Angepasste DACH Modular Intercom Firmware

V2.2.58_221227 Release Notes

Device Model	DS-KD8003-IME1 (B), DS-KD8003-IME2 (B)
Firmware Version	Modular Door Station: V2.2.58_221227
iVMS-4200 Version	V3.8.1.4
Hik-Connect APP	Neueste Version

Custom DACH Modular Intercom Firmware

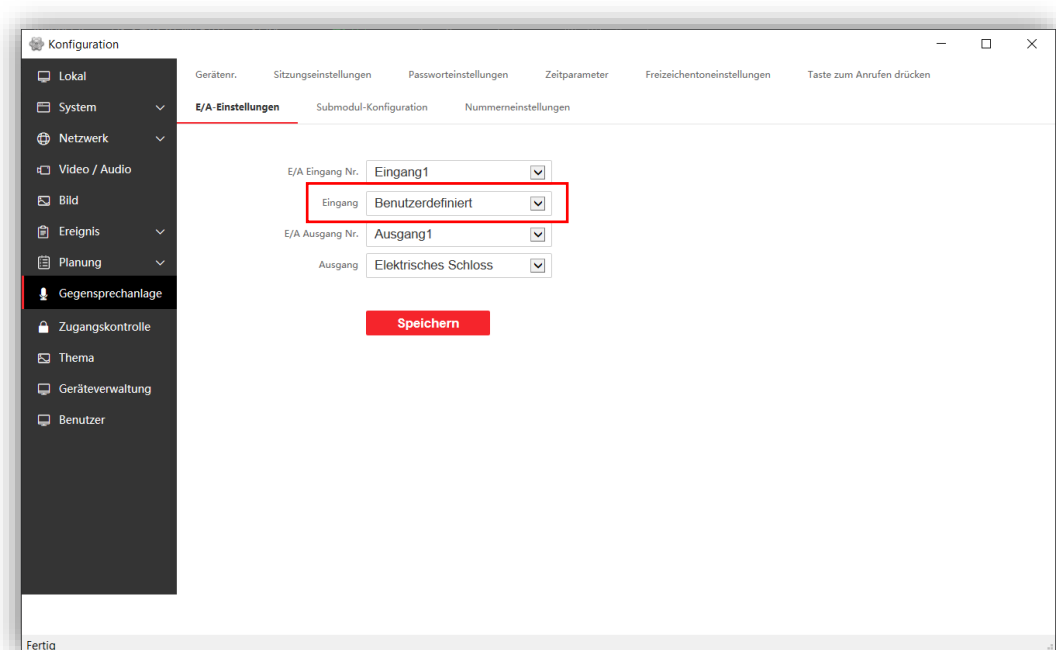
1. Der Alarm Eingang 1-4 kann für den Anschluss an externe Türklingeln verwendet werden.

- Wählen Sie im Menüpunkt E/A-Einstellungen den Wert **Benutzerdefiniert** für die **E/A Eingang Nr. 1-4**

- Speichern Sie die Einstellungen

Hinweis: Die Eingänge A1-A4 sind fix den Zimmernummern 1-4 für Innenstationen zugeordnet.

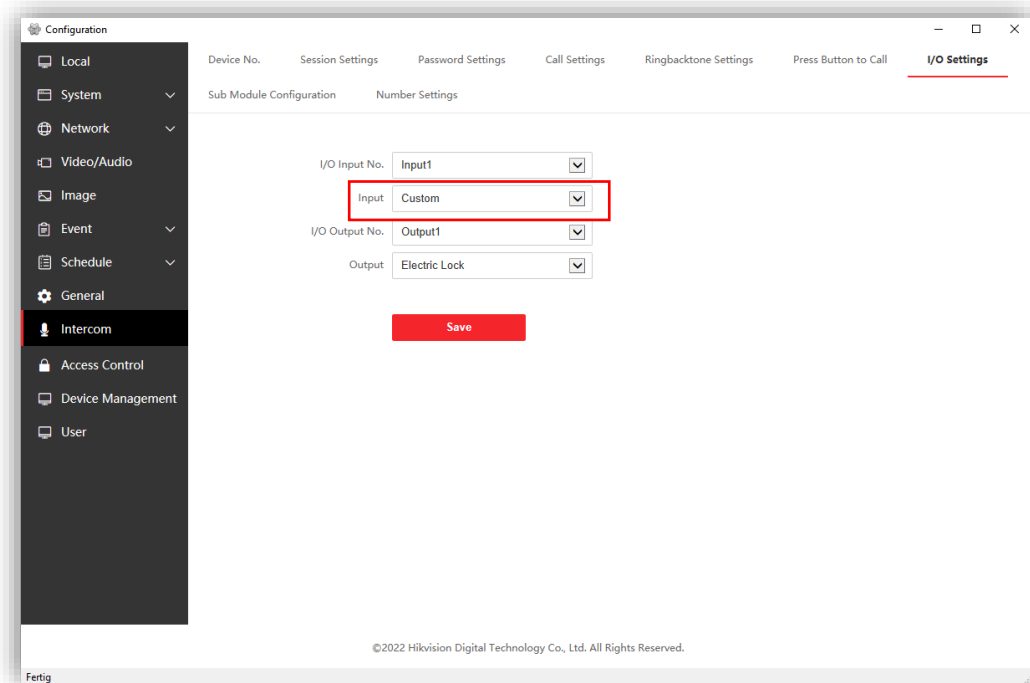
1. Alarm Input 1-4 can be assigned as “door bell” to connect existing wired door bell buttons for intercom application.

- Select Input type “Custom” to connect existing door bell
- Save setting

Note: Inputs A1-A4 are permanently assigned to room numbers 1-4 for indoor stations.
